CAMSHAFTS - S2 ENGINES

BRITISH FULL-FLOW OIL FILTERS - S2. ENGINES

V8 Engine Rocker Cover Gaskets

Service Replacement of Original Neoprene Cork Gaskets by the Silicone Rubber Type

Fig. 1. Three types of camshaft fitted to V8 engines.

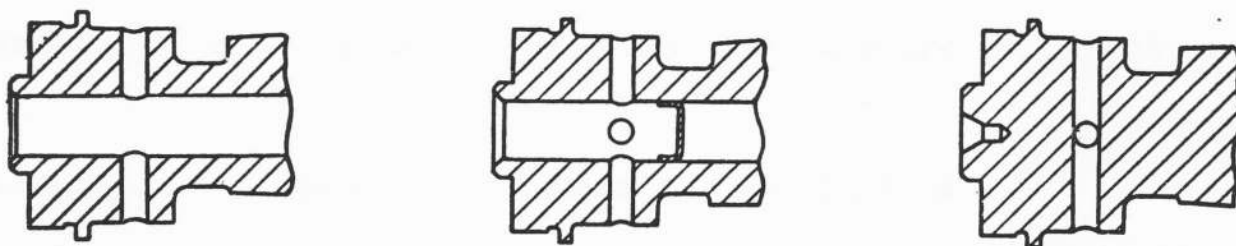
Three different methods of feeding oil to the camshaft bearings are employed on early production V 8 engines; these differences involve slight modifications to the camshaft and crankcase. The three stages of camshaft design are shown in Figure 1.

Camshafts fitted to engines employing stage one method of lubrication cannot be fitted to engines employing the second or third method.

Camshafts fitted to engines employing stage two or three method of lubrication, cannot be fitted to engines with stage one method.

Stages two and three are basically the same and camshafts fitted to engines employing either of these methods of lubrication are interchangeable; the only difference between stages two and three is a modification to the camshaft.

Fig.1. Scrap view of oil filter showing position of washers

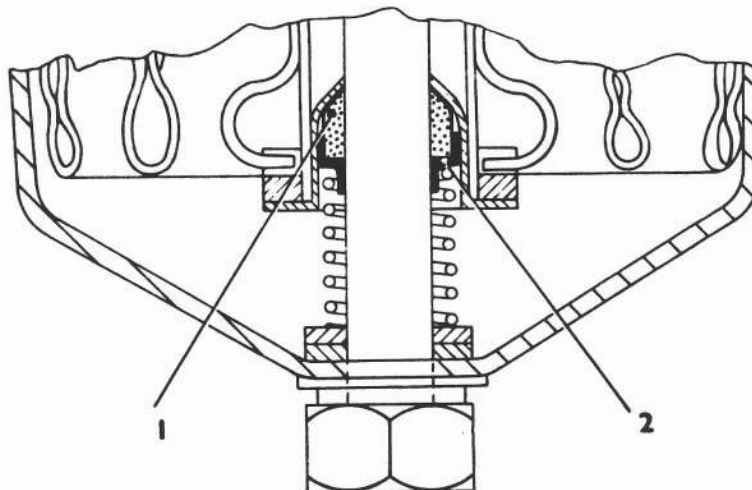
It has been established that after servicing, some oil filters have been re-assembled without the cork sealing washer and/or the metal cup washer, which should have been fitted beneath the filter element.

Failure to fit these washers, allows unfiltered oil to pass up the central tube of the filter and this can result in serious damage to the engine bearings.

When servicing an oil filter, it is essential that particular care is taken to ensure that the cork washer is in a serviceable condition and is fitted, together with the cup washer, in the correct position as shown in Figure 1.

Cork sealing washer	Part No. CD.255
Cup washer	" " CD.256

Fig.1. Modified Baffle shown in position.
'A' Area of Metal to be Removed

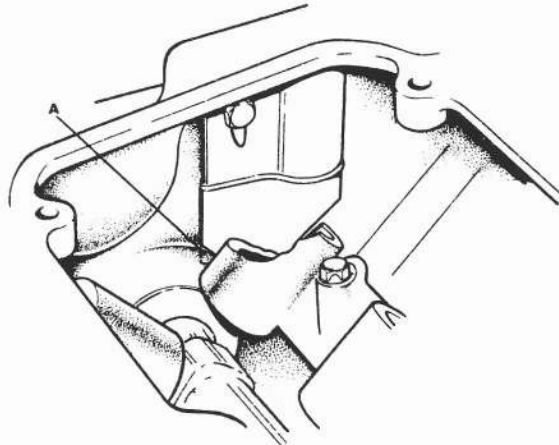
In isolated cases, loss of oil down the crankcase breather pipe on S2 cars may occur.

This is caused by the camshaft flinging oil through any gap which may exist between the breather baffle and the wall of the crankcase

Remove the baffle plate and relieve the bottom edge to ensure that it clears the boss, formed by the camshaft bearing (see 'A' in Fig 1). Fit the baffle plate in position, and if necessary bend it to ensure that it fits flush against the wall of the crankcase.

Fig.1. Position of the Oil Pressure Transmitter.

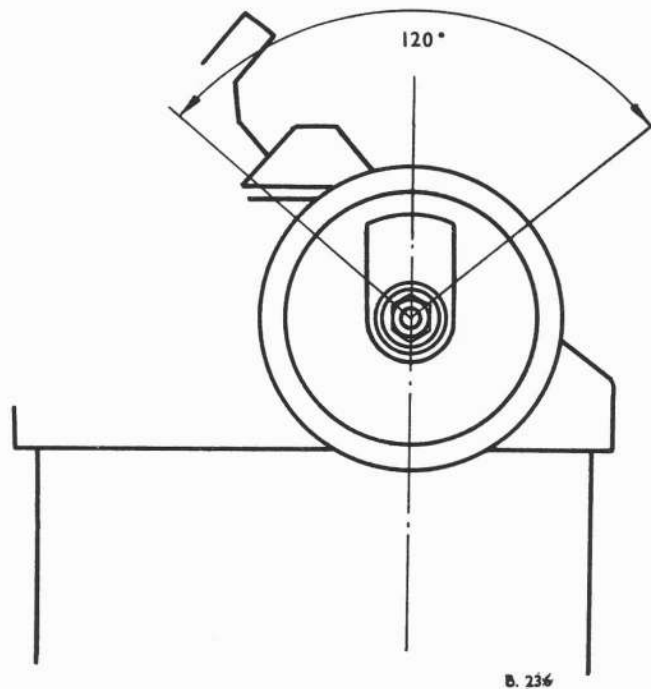
To obtain an accurate oil pressure reading on S2 engines it is essential that the oil pressure transmitter is correctly assembled to the oil filter head.

The transmitter should be fitted so that the raised portion of the cover is to the top of the filter and within 60° of either side of the vertical datum. (See Fig.1).

The correct position of the transmitter can be obtained by fitting additional copper washers to the threaded union.

The part number of the copper washer is UD.8017
